TRANS/WP.29/GRE/2001/32
19 July 2001

PROPOSAL FOR DRAFT AMENDMENTS (SUPPLEMENT 22 TO THE 02 SERIES)
TO REGULATION No. 37

(Filament lamps)

Transmitted by the Expert from the Working Party "Brussels 1952" (GTB)

The drawings are intended only to illustrate the essential dimensions (in mm) of the filament lamp

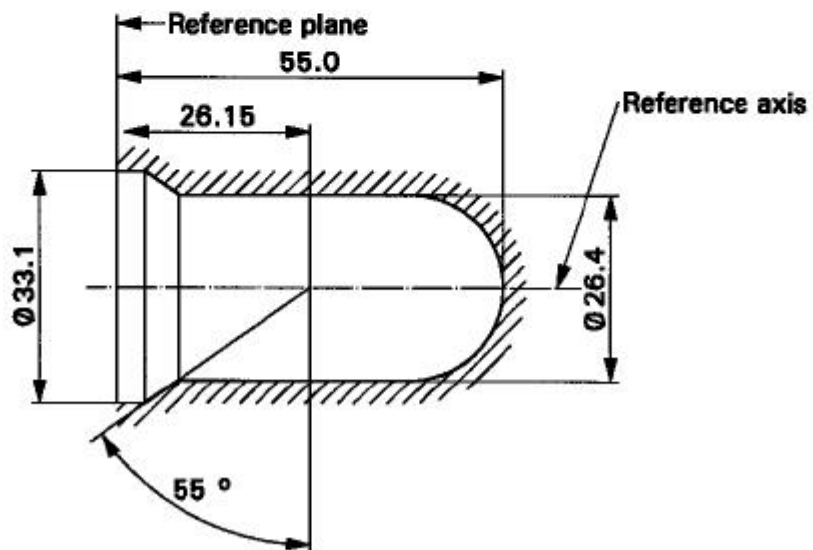
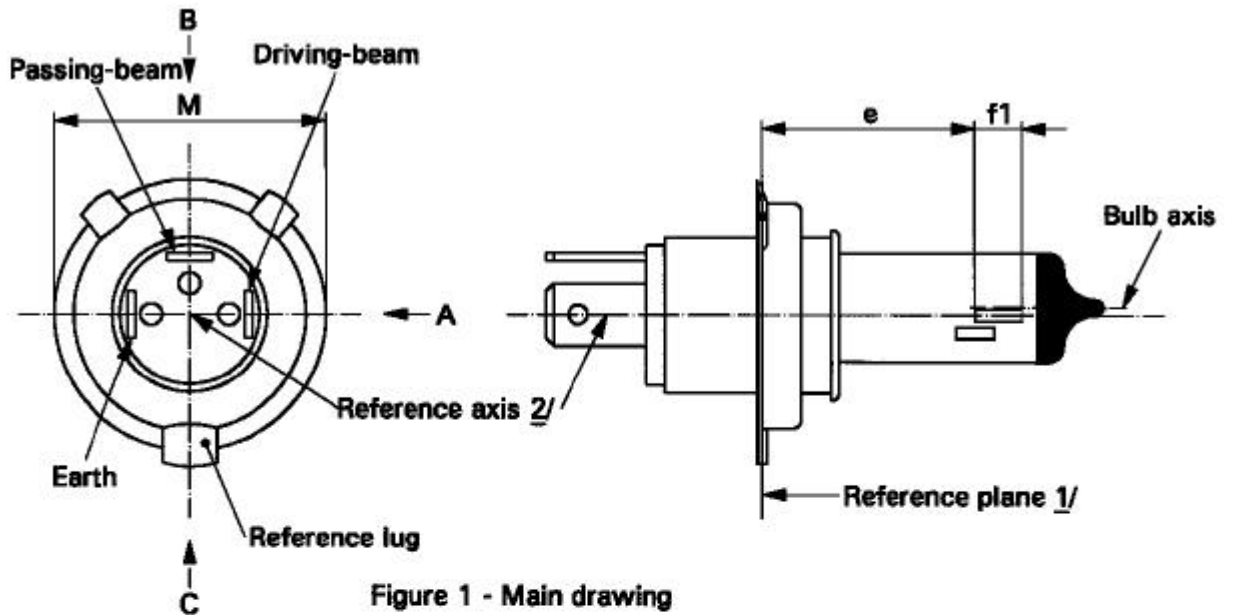
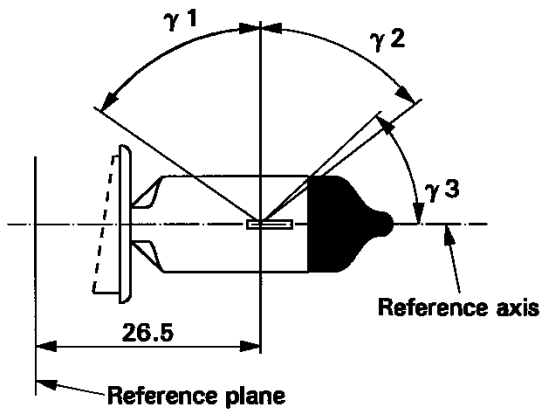
Add at the end new data sheets H14/1 to H14/4, to read:

- 1/ The reference plane is defined by the points on the surface of the holder on which the three lugs of the cap ring will rest.
- 2/ The reference axis is perpendicular to the reference plane and passing through the center of the cap ring diameter 'M'.
- 3/ Glass bulb and supports shall not exceed the envelope as indicated in figure 2. The envelope is concentric to the reference axis.

View B Figure 3 - Distortion free area 4/
and black top 5/

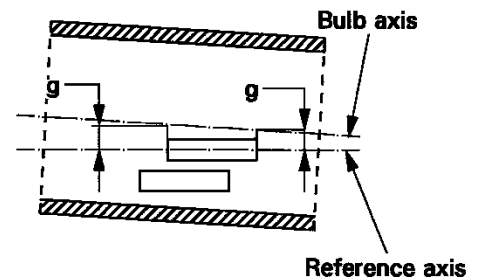
- 4/ Glass bulb shall be optically distortion free within the angles γ_1 and γ_2 . This requirement applies to the whole bulb circumference within the angles γ_1 and γ_2 .

- 5/ The obscuration shall extend at least to angle γ_3 and shall extend at least to the cylindrical part of the bulb on the whole bulb top circumference.

View A View B,C Figure 5- Offset of filament axis 7/
(for standard filament lamps only)

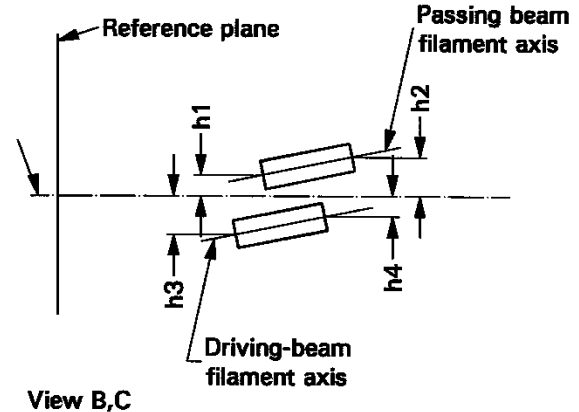
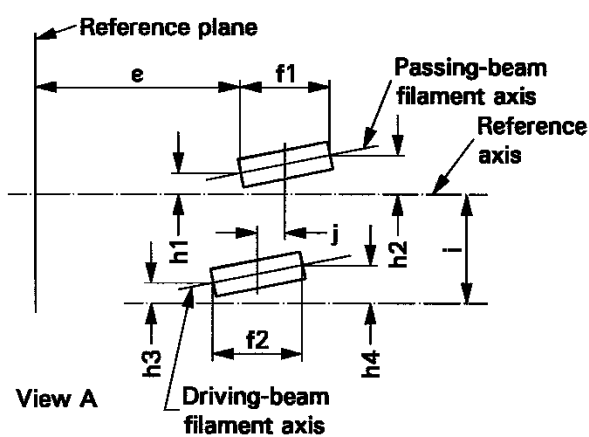
- 6/ Eccentricity of bulb with respect to passing-beam filament axis is measured in two planes parallel to the reference plane where the projection of the outside of the end turns nearest to or furthest from the reference plane crosses the passing-beam filament axis.

- 7/ The offset of the filaments with respect to the reference axis is measured only in viewing direction A, B and C as shown in figure 1 on sheet H14/1. The points to be measured are those where the projection of the outside of the end turns nearest to or furthest from the reference plane crosses the filaments axis.

Screen projection requirements

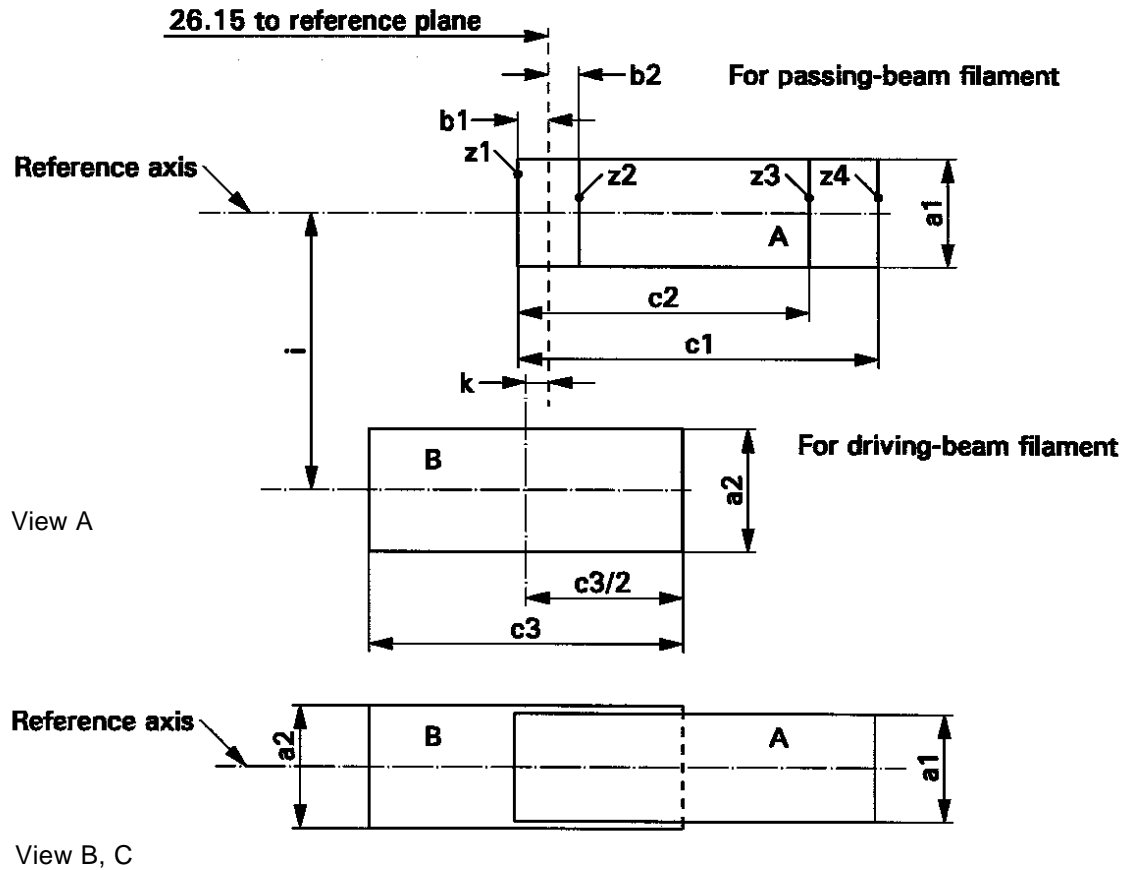
This test is used to determine, by checking whether the filaments are correctly positioned relative to the reference axis and the reference plane, whether a filament lamp complies with the requirements.

The positions of the filaments are checked solely in directions A, B and C as shown in figure 1 on sheet H14/1.

The passing-beam filament shall lie entirely in the rectangle A and the driving beam filament entirely in rectangle B

The ends of the passing-beam filament as defined on sheet H14/3, note g/ shall lie between lines Z1 and Z2 and between lines Z3 and Z4.
